File No. 04-1000-20-2016-466

Re: Request for Access to Records under the Freedom of Information and Protection of Privacy Act (the "Act")

1. Entire (18 page) document called Point Grey Road Sidewalk Widening Details (see attached page 17 of 18); and
2. Any reports, emails and submissions for proposed seating arrangements (benches in circles, some with bike racks as per Drawing No. 2016-20-D.L. 4.1) as part of Phase 2 construction on Point Grey Road from August 1, 2016 to November 30, 2016.

APPROVALS	INITIALS	CONTACT	REVISIONS / DESCRIPTION	INITIALS	ENGINEERING SERVICES – CITY OF VANCOUVER – TRANSPORTATION DESIGN	
	LANDSCAPE ARCHITECT					DESIGNED BY: APL	Point Grey Road Sidewalk Widening Details
	PROJECT ENGINEER					DRAFTED BY: APL	
	CONSTRUCTION COORDINATOR			ACCOUNT #:		CHECKED BY:	
	LANDSCAPE DESIGNER			DIRECTORY: H:\TRANSPORTATION_DIVISION\13-1400-30\Point Grey Road - Phase 2 (0000111)\11 - Design\landscape Design\ENG - TDE - 2016-20 - Detail Plan.dwg DATE: Aug 30, 2016 - 2:31pm USER: enapl		FILE NAME: ENG - TDE - 2016-20 - Detail Plan.dwg	
						SCALE: 1:50 DATE: August 2016 DWG. NO. 2016-20-D-L4.1 REV. NO. SHEET: 17 OF 18

Seating Area 1 - Detail Layout

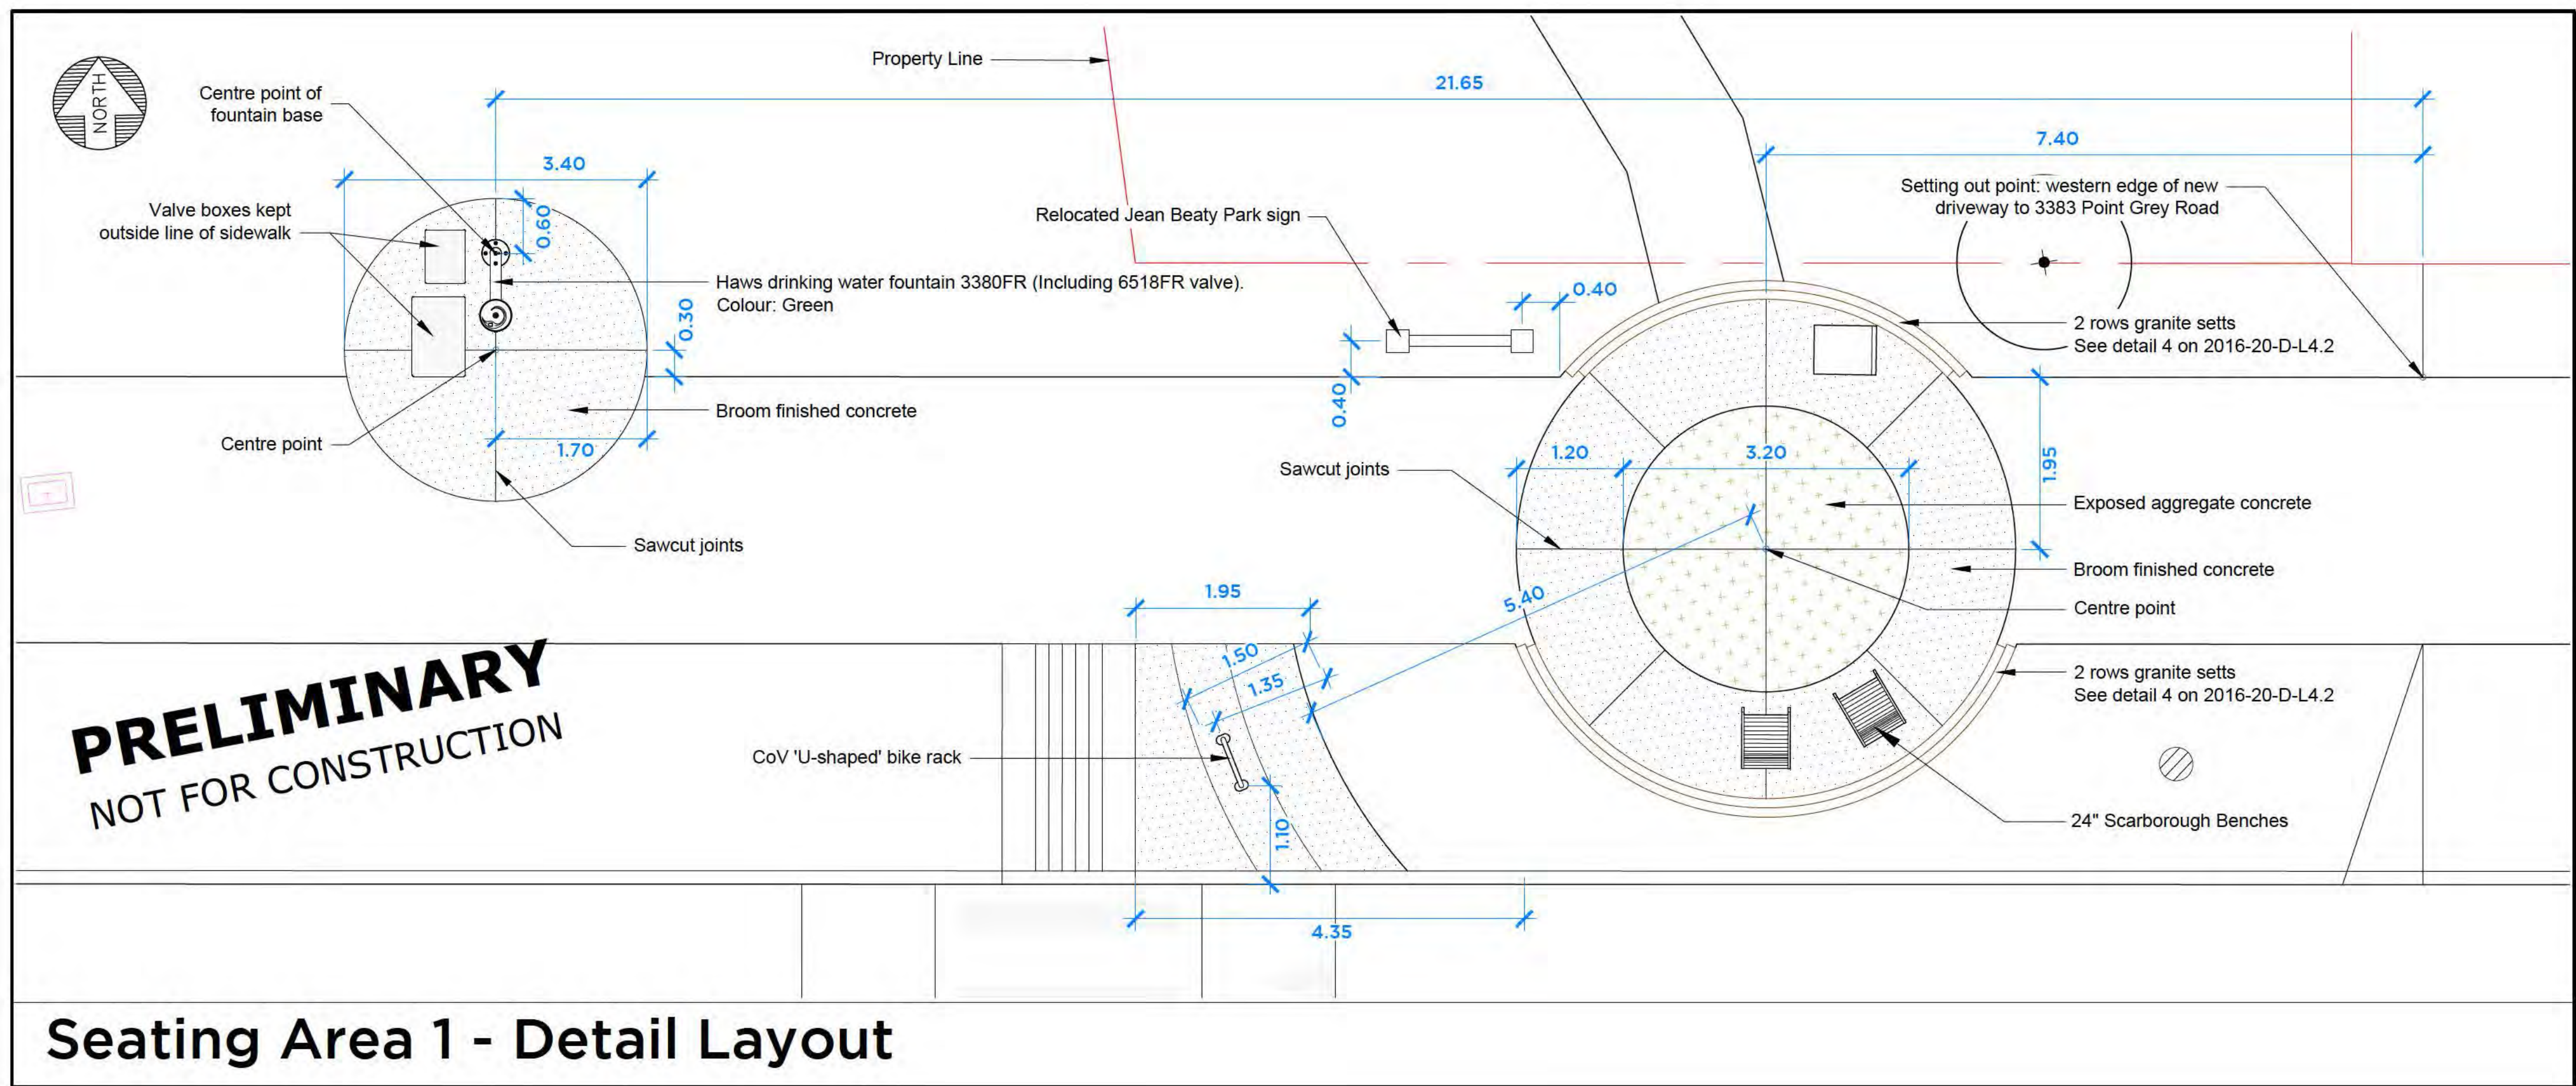
I spoke to Joe & Tiina and both thought shifting the circular feature south so it doesn't encroach into the park would be the best solution.

One of these proposed seating areas is located at the south east corner of Jean Beaty Park. I attach a sketch of the layout (*LSK250716-1*) and a streetview snapshot of the area. You will note that there is a small segment of the seating area that protrudes into the actual park site. In addition the new sidewalk is on a different alignment to the existing path and will remove the southwest corner of an existing planted mound.

I shifted the seating area south and have attached the revised layout for your info. Thanks for your help on this.
